Form C-103  
May 27, 2004

WELL API NO. 30-039-27706
5. Indicate Type of Lease STATE <input type="checkbox"/> FEE <input type="checkbox"/>
6. State Oil & Gas Lease No.
7. Lease Name or Unit Agreement Name RINCON UNIT
8. Well Number #404
9. OGRID Number 189071
10. Pool name or Wildcat BASIN DAKOTA/BLANCO MESAVERDE

SUNDRY NOTICES AND REPORTS ON WELLS  
(DO NOT USE THIS FORM FOR PROPOSALS TO DRILL OR TO DEEPEN OR PLUG BACK TO A DIFFERENT RESERVOIR USE "APPLICATION FOR PERMIT" (FORM C-101) FOR SUCH PROPOSALS)

OTHER: CHANGE OF PLANNED FACILITIES ☒

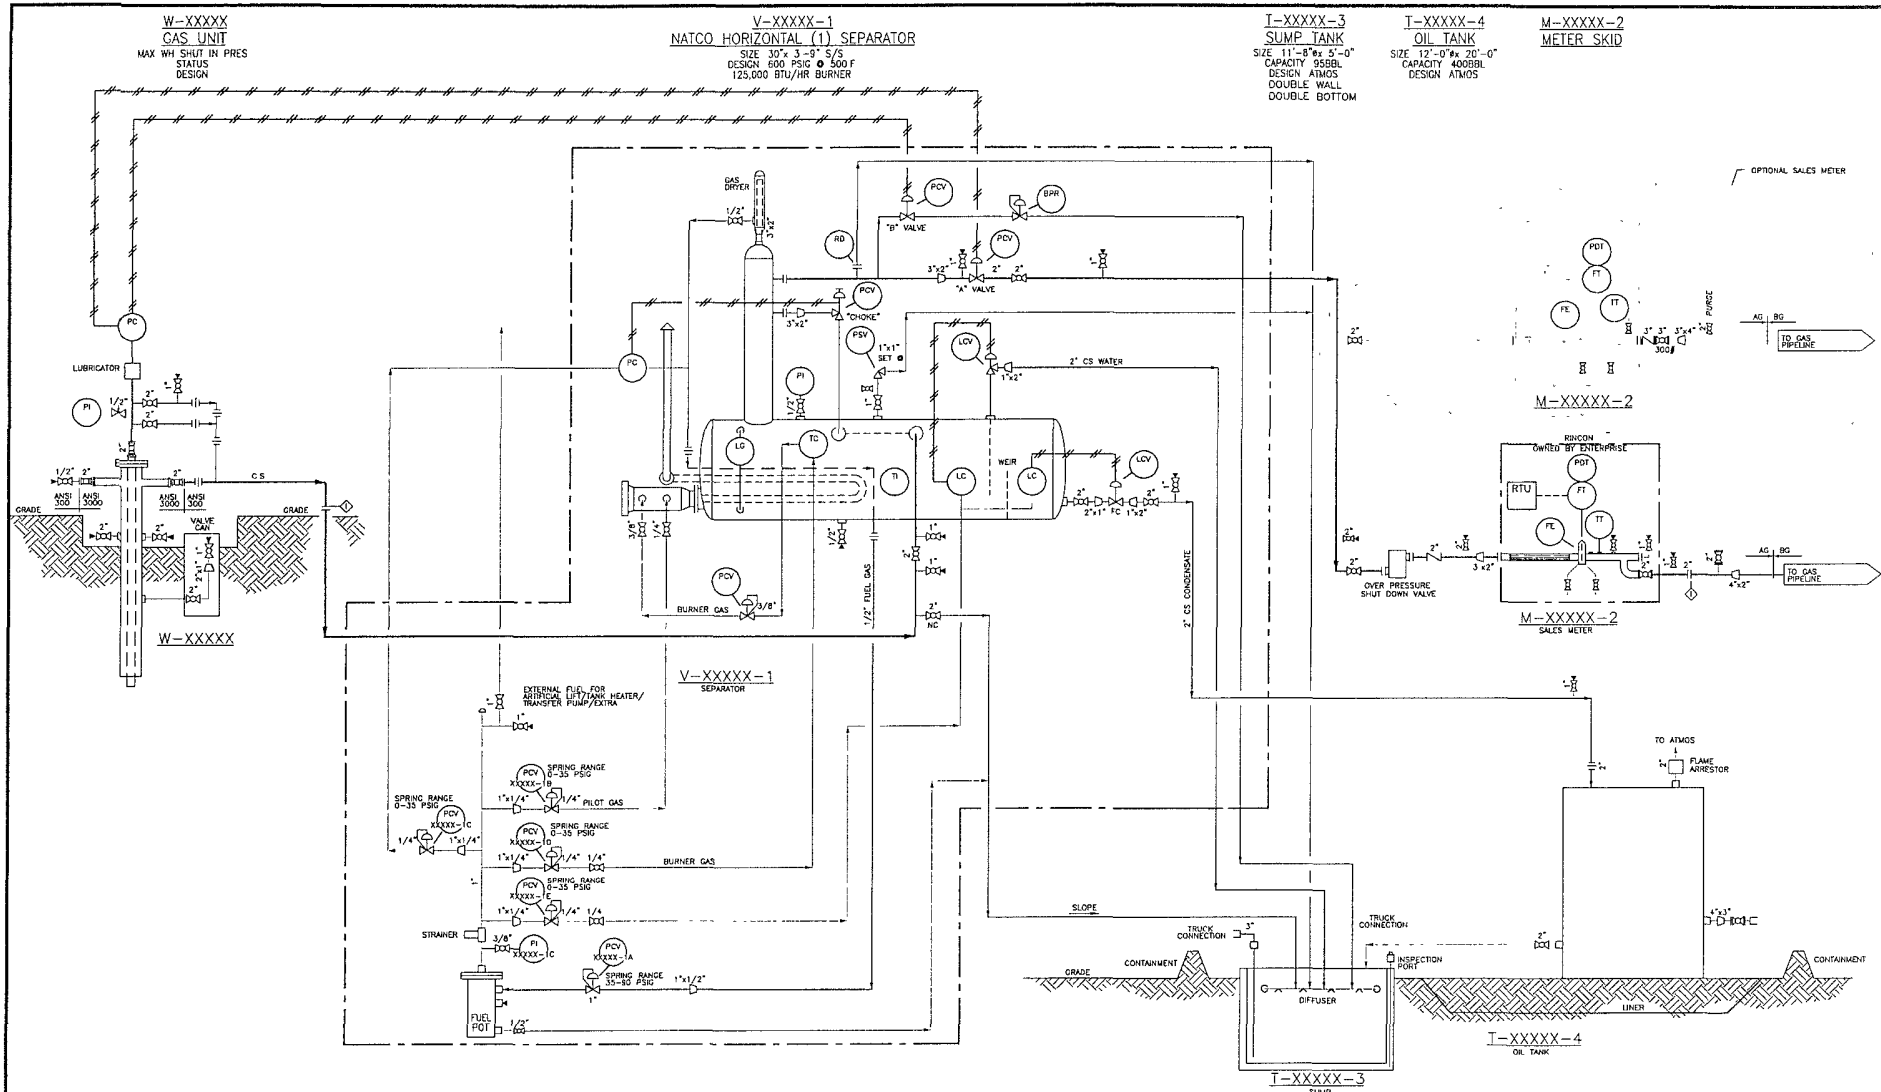
Chevron MidContinent, L.P. reports that we have changed our planned facilities for the above mentioned location. A ~400 BBL steel tank, a ~95 BBL below-grade steel tank, a separator, and an Enterprise meter run will be installed on the well pad. Attached is a basic diagram of how these facilities would be arranged on a wellsite and a basic diagram of the 95Bbl below-grade steel tank. Should you have any questions or require any additional information, please feel free to contact us at anytime.
